WELL API NO. 30-015-44754
5. Indicate Type of Lease STATE ☐ FEE ☒
6. State Oil & Gas Lease No.
7. Lease Name or Unit Agreement Name Spud Muffin 31-30
8. Well Number 735H
9. OGRID Number 6137
10. Pool name or Wildcat (98220) PURPLE SAGE; WOLFCAMP

SUNDRY NOTICES AND REPORTS ON WELLS
(DO NOT USE THIS FORM FOR PROPOSALS TO DRILL OR TO DEEPEN OR PLUG BACK TO A DIFFERENT RESERVOIR. USE "APPLICATION FOR PERMIT" (FORM C-101) FOR SUCH PROPOSALS.)

PERFORM REMEDIAL WORK ☐ PLUG AND ABANDON ☐
TEMPORARILY ABANDON ☐ CHANGE PLANS ☐
PULL OR ALTER CASING ☐ MULTIPLE COMPL ☐
DOWNHOLE COMMINGLE ☐
CLOSED-LOOP SYSTEM ☐
OTHER: BHL CHG ☒

Devon Energy Production Company, LP Respectfully requests approval to change the Surface Hole and Bottom Hole per the following:

RECEIVED
WELL LOCATION AND ACREAGE DEDICATION PLAT

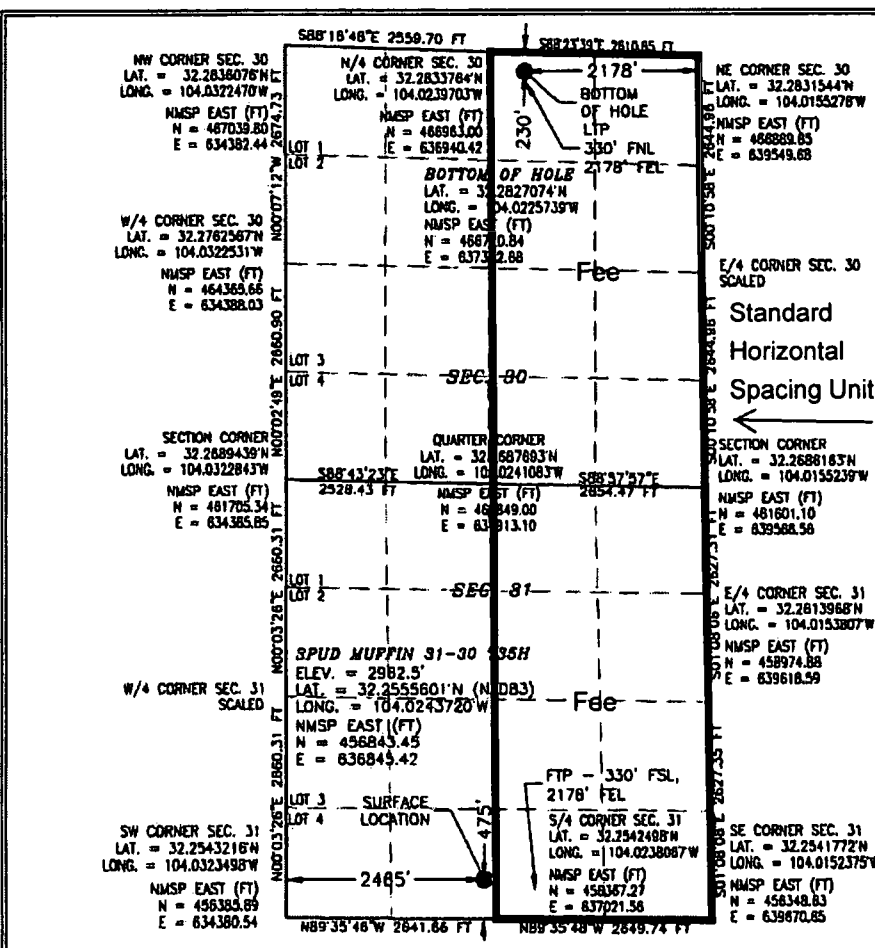
From: Sec. 31, T23S, R29E 475 FSL, 2075 FEL - Unit O
To: Sec. 31, T23S, R29E 475 FSL, 2465 FWL - Unit N

From: Sec. 30, T23S, R29E 230 FNL, 2310 FEL
To: Sec. 30, 23S, 29E, 230 FNL, 2178 FEL

From: 2962.7 to 2962.5

UL or lot no.	Section	Township	Range	Lot Idn	Feet from the	North/South line	Feet from the	East/West line	County
N	31	23 S	29 E		475	SOUTH	2465	WEST	EDDY

UL or lot no.	Section	Township	Range	Lot Idn	Feet from the	North/South line	Feet from the	East/West line	County
B	30	23 S	29 E		230	NORTH	2178	EAST	EDDY
